#### **Tdoc NP-010580**

## 3GPP TSG CN Plenary Meeting #14 Japan, Kyoto, 12<sup>th</sup> – 14<sup>th</sup> December 2001

Title: CR on R98, Work Item CAMEL2, Pack 1

Spec	CR	Rev	Doc-2nd-Level	Phase	Subject	Cat	Ver_C
03.78	A165		N2-010726	R98	Re-insertion of missing CLI box into CAMEL	F	7.6.1
					Release 1998

Figure 24c: Procedure CAMEL\_MT\_GMSC\_INIT (sheet 3)

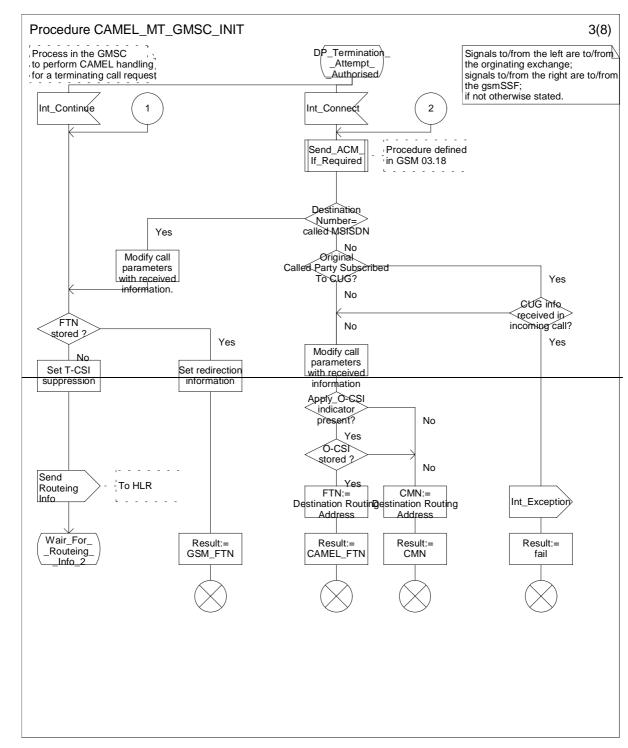
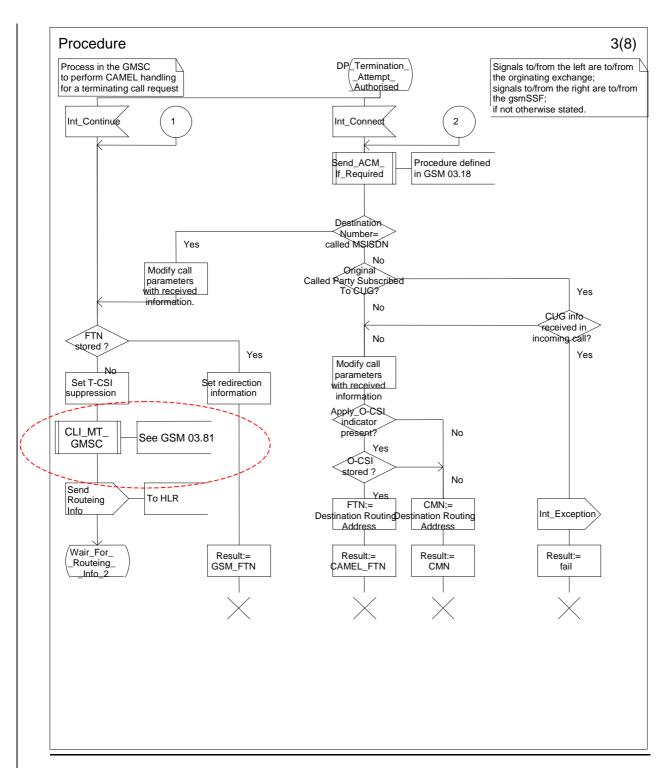
Reason for change:   CAMEL Phase 2 Release 1998 introduces the 03.81 Line identification supplementary services. A procedure call was introduced in the SDLs. This procedure call box has now disappeared.								
Summary of change:  To include the procedure call box back into 03.78								
Consequences if not approved:	# Incorrect specification.							
Clauses affected:								
Other specs affected:	# Other core specifications # Test specifications O&M Specifications							
Other comments:	# No CR is needed against later CAMEL Phases, as this box is still included there.
